DESCRIPTIVE REPORT

ST. HELENA SOUND

HARBOR RIVER

REVIEW OF AIR PHOTO COMPILATION NO. T- 5187.

Cherry Hill Knoll Island

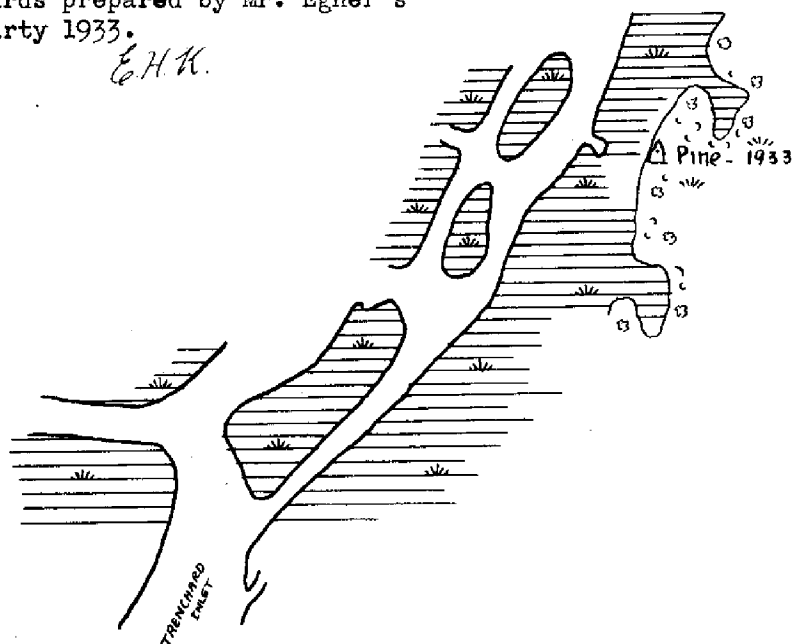
With the addition to the descriptive report please note the sketches at triangulation station CHERRY HILL KNOLL and PINE. Triangulation station CHERRY HILL KNOLL was recovered by Mr. Egner in 1933 and PINE was established by Mr. Egner in 1933. He prepared descriptions for both stations in 1933 and these sketches were traced from those on the back of his description cards. Please note the general agreement in the trend of the H.W.L. and high ground line between these sketches and the Air Photo Compilation. Also please note the agreement in symbols on the sketches and the air photo sheet. In comparing these sketches with the detail on the topo sheet no similarity is apparent.

The high water line at this point is indefinite on the photographs and is shown on the compilation as such. However, the photos are definite enough to show that the high water line should not be as far back as that on the topo sheet. Hence, we feel sure that the topo sheet is in error. See enclosed sketch of triangulation station CHERRY HILL KNOLL.

See enclosed sketch of triangulation station PINE.
